Appl No 10/805,032
Amdt dated October 31, 2006
Reply to Office Action of May 31, 2006

Amendments to the Drawings:

Figure 9

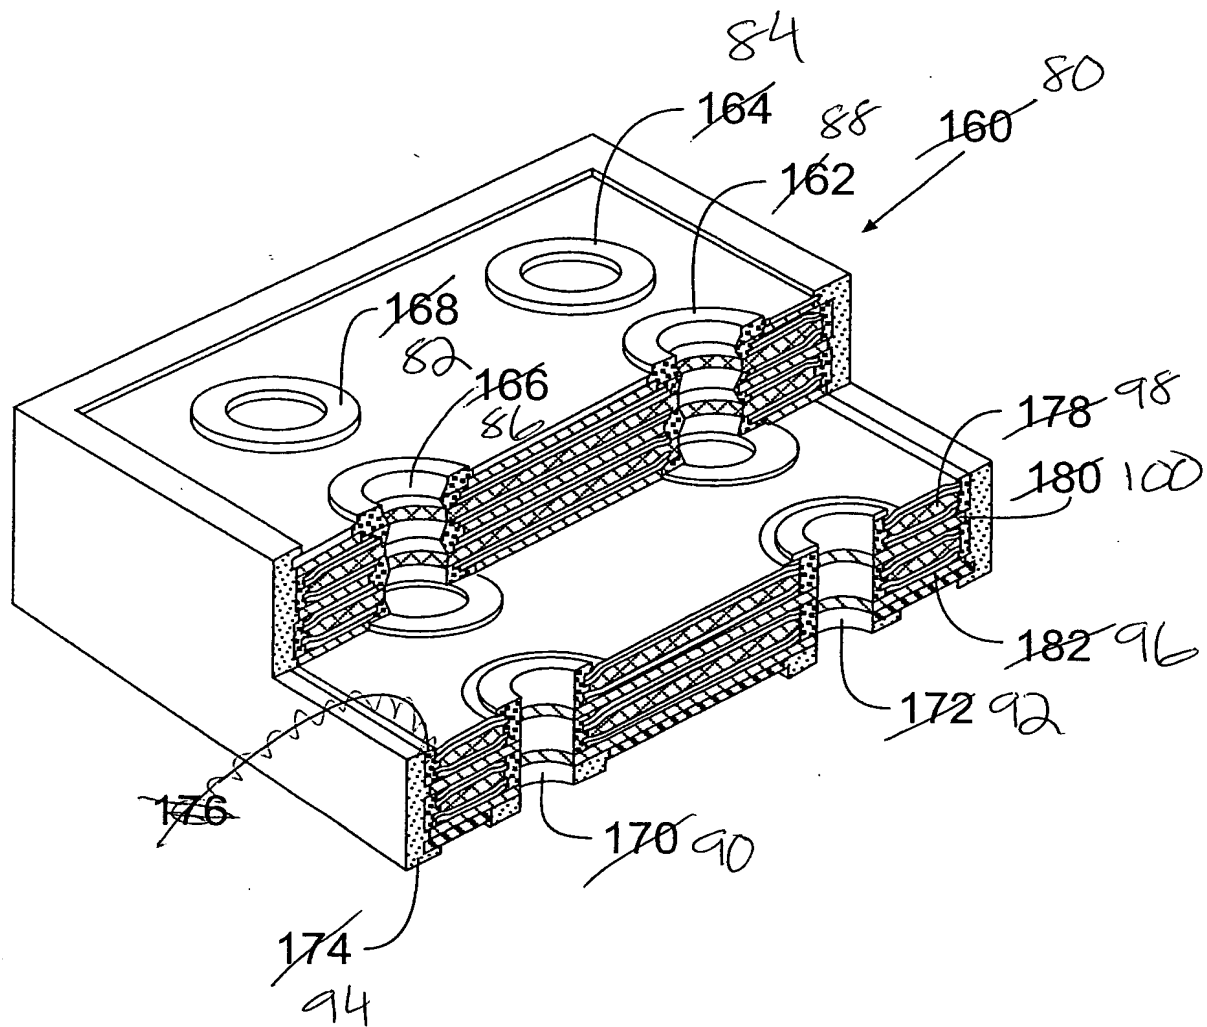
Figure. 9 is being amended to correct the reference numerals to correspond with the reference numerals referred to in the specification as originally filed. No new subject matter is being introduced. Amendments to Figure. 9 are indicated on the attached Annotated Sheet of drawing.

The attached Replacement Sheet of drawings includes changes to Figure. 9 only. The Replacement Sheet replaces original Figure. 9.
